# CITY OF ALBUQUERQUE

**RE: All-Rite Construction Warehouse  
Grading and Drainage Plan  
Stamp Date: 12/19/17  
Hydrology File: K09D042**

**RE: All-Rite Construction Warehouse  
Grading and Drainage Plan Stamp  
Date: 12/09/17  
Hydrology File: K09D042**

The following is a response to your hydrology comments on the submittal plans. The item numbers below refer to your comments:

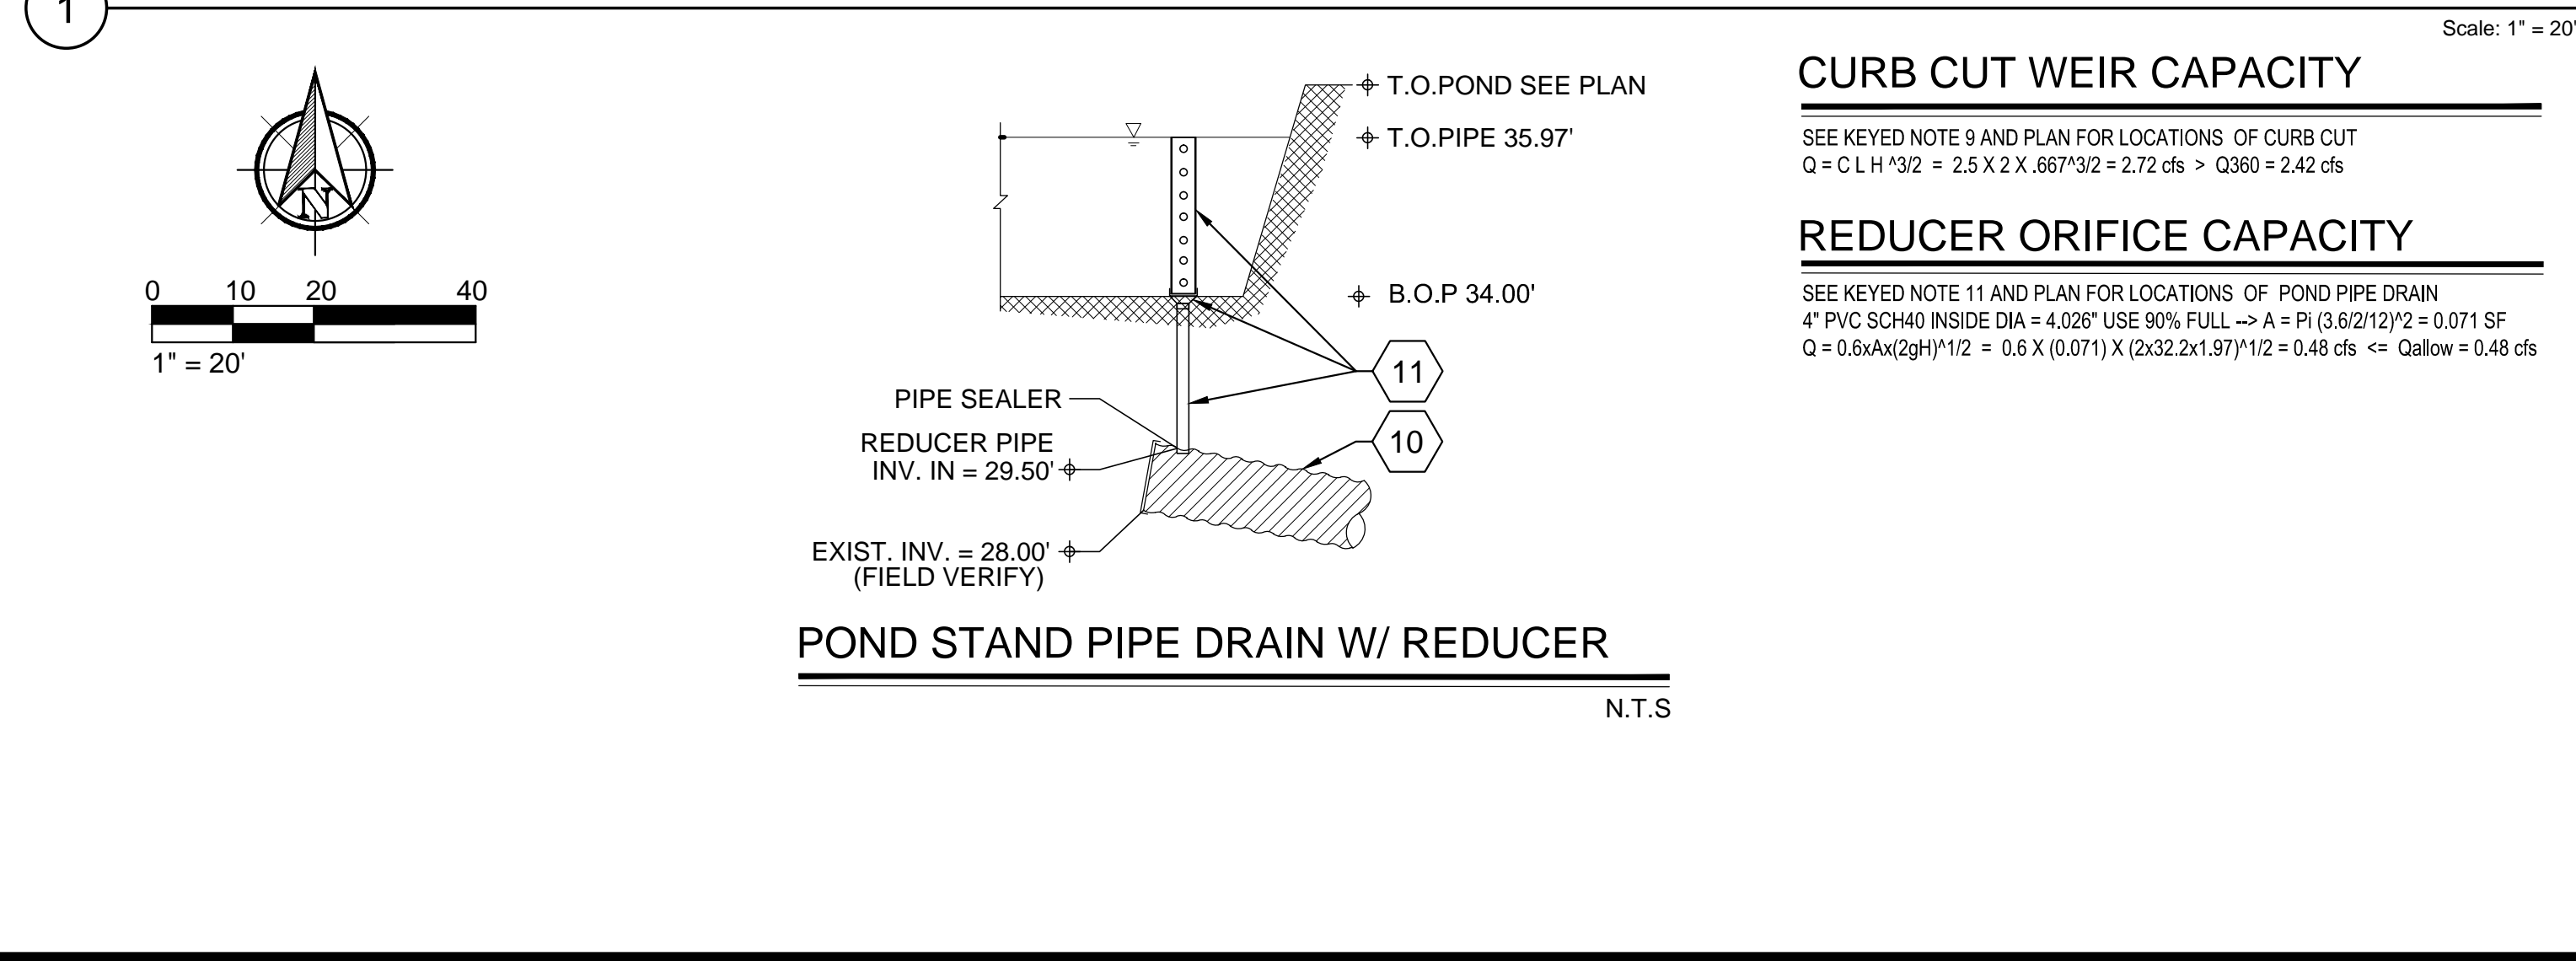
1. Effective date has been added to the FIRM information. Refer to sheet C-101 dated 12/19/17.
2. Water block per COA Paving Detail No. 2426 at the driveway has been updated on grading plan. Refer to sheet C-101 dated 12/19/17.
3. First flush drainage has been routed through the first flush ponding area and will be discharged into existing storm drainage system in Oliver Ross Drive. Refer to sheet C-101.
4. Offsite discharge has been limited to 0.48cfs per master drainage plan. Refer to keyed note #11 on sheet C-101 dated 12/19/17.
5. Offsite discharge has been limited to 0.48cfs per master drainage plan and will discharge into the existing 18" CMP stub out per master plan. Refer to keyed note #11 on sheet C-101 dated 12/19/17.
